INTERNAL
CORRESPONDENCE

NPM 2002-0599

To: T. Klesper J. McNamara
From: A. J. Cayia *A. J. Cayia*
Date: November 8, 2002
Subject: AFW RECIRCULATION LINE ORIFICE EVALUATION
Copy To: T. Taylor D. Schoon J. Boesch S Thomas G Corell
R. Milner J. Freels T. Webb M. Schug File

AFW Recirculation Line Orifice Evaluation

TO SHIP OFFICE ASSEMBLY FOR BYRON JACKSON S/H 121 10 2 5
 TEST PRESSURE 1500 PSIG
 TEST PRESSURE 1500 PSIG
 FLOW : CIA
 DRAWING ITEM 1001
 RELATED TO DRAWING ITEM 002 ITEM 002
 CONTROL THE FROM BRANCH
 DRAWING #DWG005955

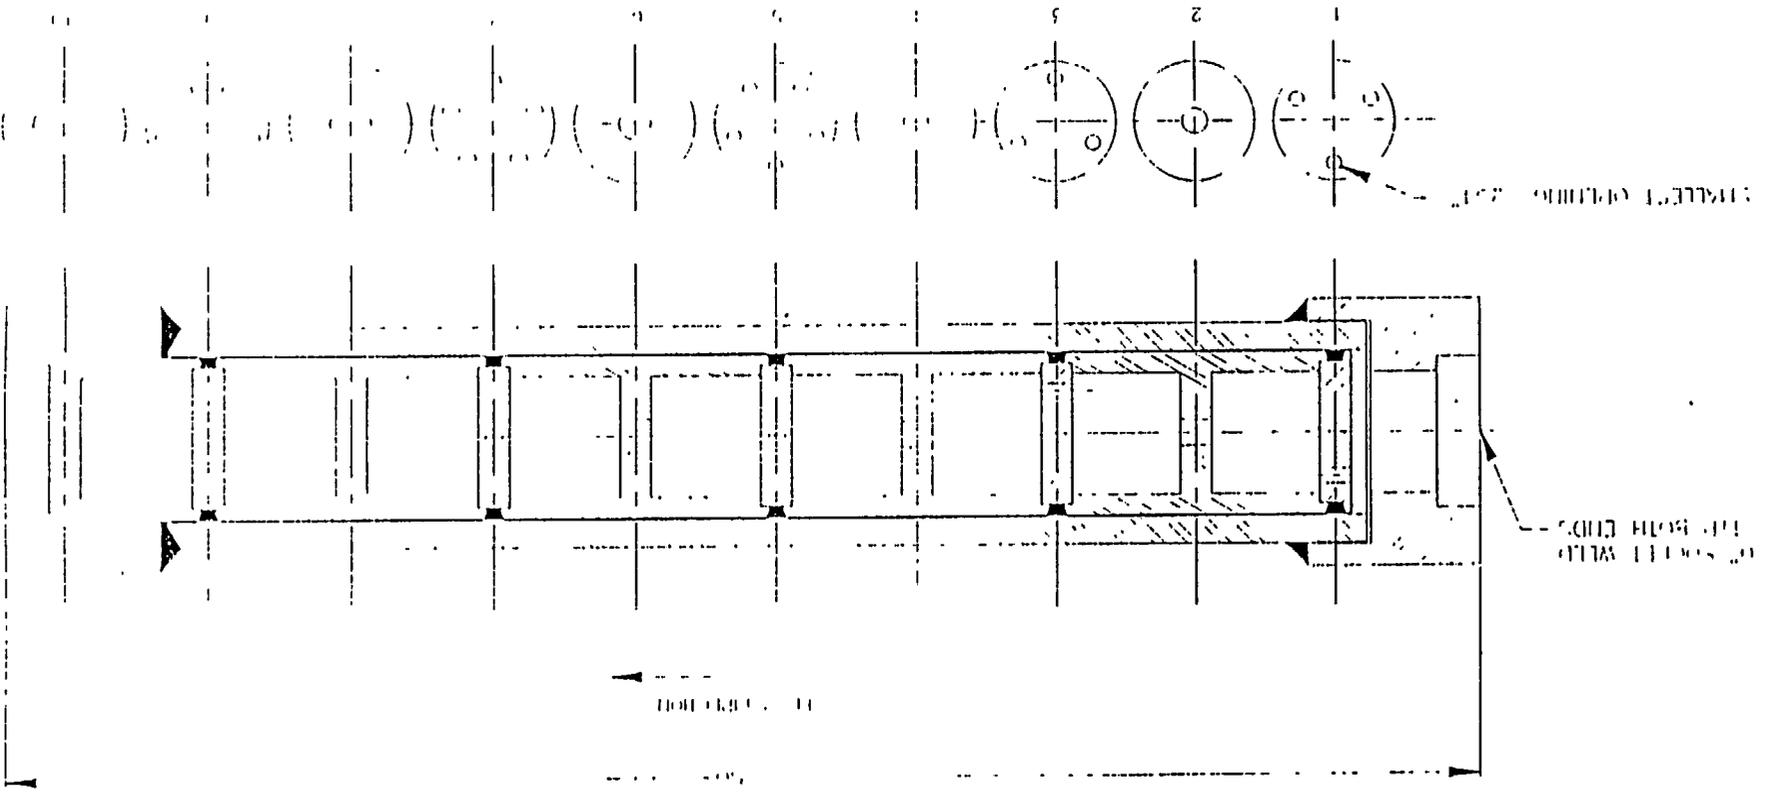
The valve division's design can be assembled. The cost of disassembly is a higher probability of failure. The threaded retainer could come loose. Threaded in valve cages (similar design) are locked in with welded locks. The downstream retaining ring is a snap ring. If the element does cavitate, this area would pit and cause snap ring failure. Zion used a 7-stage orifice (similar number of stages) and saw degradation in this area after years of service. The o-rings have a service life and will degrade. Leakage past the o-rings will cut the area, similar to steam cutting on valve seats. The valve division's design will only fit in two of the recirculation lines, without line rerouting. Flanges are not required or recommended. The elements should not require cleaning since the openings are sized for Service Water. Previously welded in orifices have been inspected in place, probably though the flow meter orifice, refer to RCE 99-081.

I recommend using the pump divisions design. The orifices are available in 8 weeks with expediting at a cost of \$130,000. These flow orifices were designed analytically, if actual flow tests are required additional costs will be incurred.

The panel endorsed the ten-stage flowserve pump division orifice. Engineering was directed to proceed with detailed design and procurement of two orifices for the motor driven pumps and two orifices for the steam driven pumps on an expedited basis. Engineering was also requested to verify that the orifices for the motor driven pumps should be expedited first because of their importance from a risk standpoint. The next review is to be scheduled at the completion of detailed design.

PLEASE REFER TO THE ATTACHED TYPICAL SKETCH FOR DESIGN DETAILS

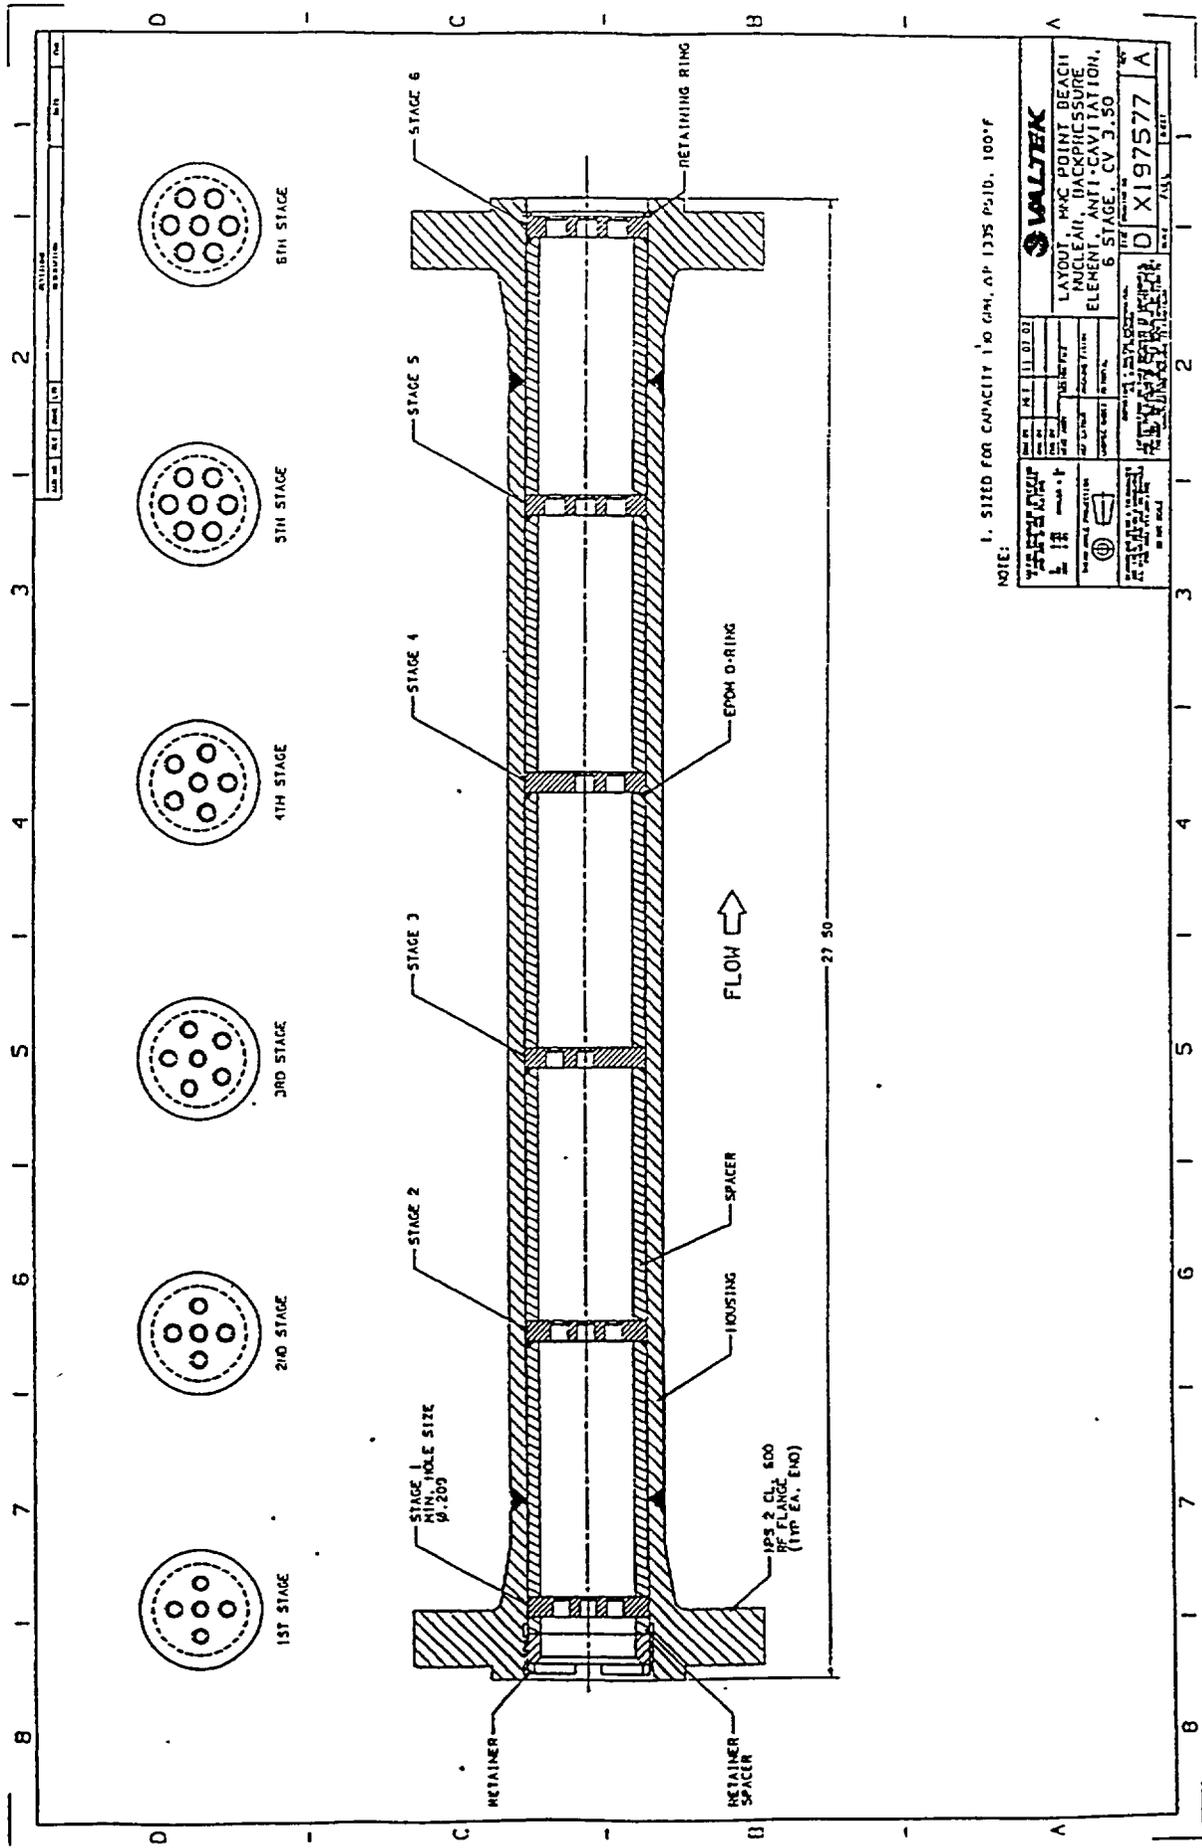
The valve division wants adjustability to ensure meeting flow rates, and the retainers could be seal welded after final adjustment. Since the recirculation flow does not need to be 126 gpm and 89 gpm as stated in the FSAR. A larger flow rate window is acceptable and the FSAR will be changed.
